Office Action Summary	Application No.	Applicant(s)	
	10/814,478	STIGLER, MARIO	
	Examiner	Art Unit	
	Alfred Joseph Wujciak III	3632

This is the non-final Office Action for the serial number 10/814,478, RETAINING CLIP WITH OFFSET LATCHING FINGERS, filed on 3/31/04.

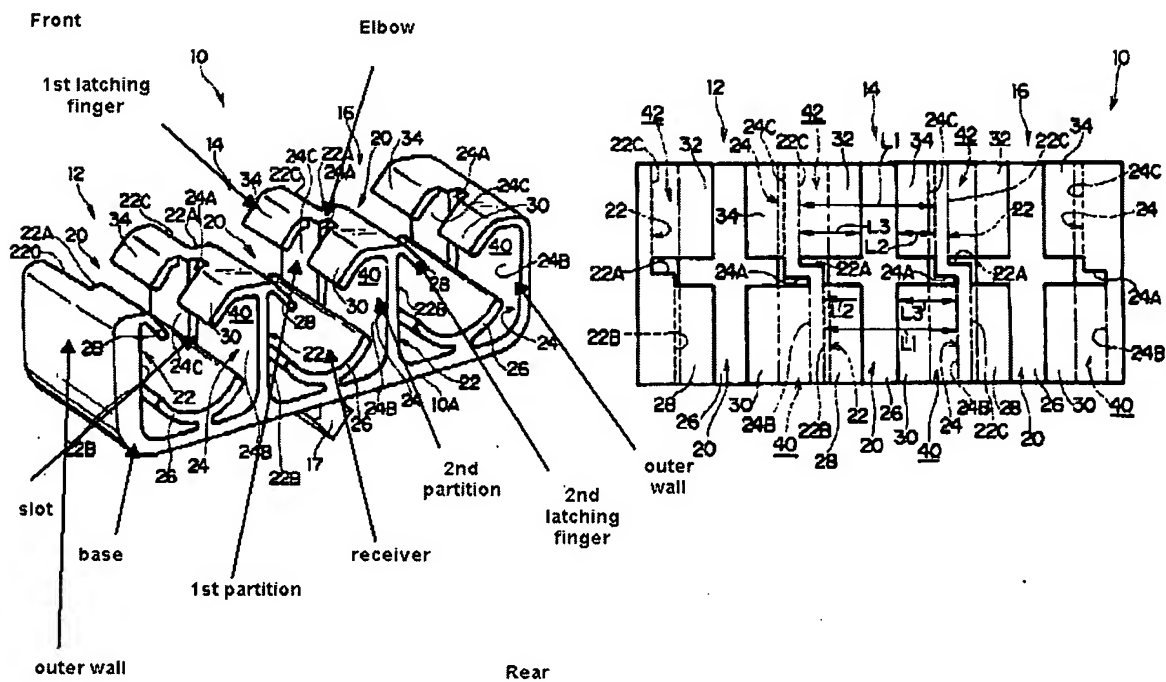
Tetsushi teaches a retaining clip having a base part with receivers and first and second generally parallel partitions between two receivers. The receiver comprises a front side and a rear side. The clip includes at least one first latching fingers coupled to the first partition at the front side and at least one second latching finger coupled to the second partition at the rear side of the receiver. The first and second latching fingers are smaller than the width of the first and second partitions. The first latching finger is arranged offset relative to the second latching finger. The elbow is disposed between the first and second partitions. The first and second partitions have an opening in the form of a slot.

Tetsushi teaches the elbow but fails to teach the elbow having a length about the length of the first and second partitions. It would have been obvious for one of ordinary skill in the art at the time the invention was made to have modified the length of elbow to about the length of the first and second partitions to provide designer's preference for the distance between the first and second latching fingers for retaining object in the receiver.

Tetsushi teaches the first latching finger is arranged laterally offset relative to the second latching finger but fails to teach the distance between the first finger and second finger is 5 to 20% of the width of the partition. It would have been obvious for one of ordinary skill in the art at the time the invention was made to have modified distance between first latching finger and second latching finger to 5 to 20% of width of partition to prevent the first latching finger from interfering the second latching finger when an object is secured in the receiver.

FIG. 4

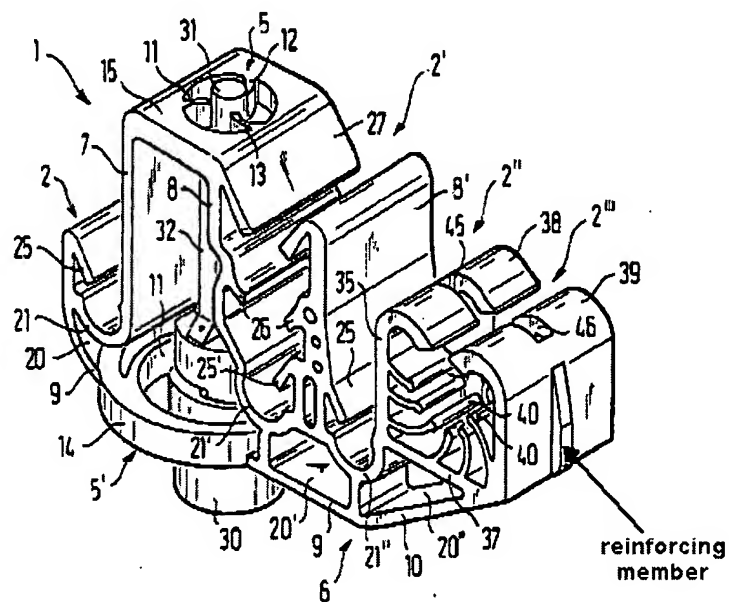
In regards to claim 8, Tetsushi teaches the outer walls but fails the walls are reinforced by reinforcing structures. Kraus teaches the outer wall being reinforced by reinforcing structure. It would have been obvious for one of ordinary skill in the art at the time the invention was made to have added reinforcing structure to Tetsushi's outer walls as taught by Kraus to prevent the outer walls from collapsing.
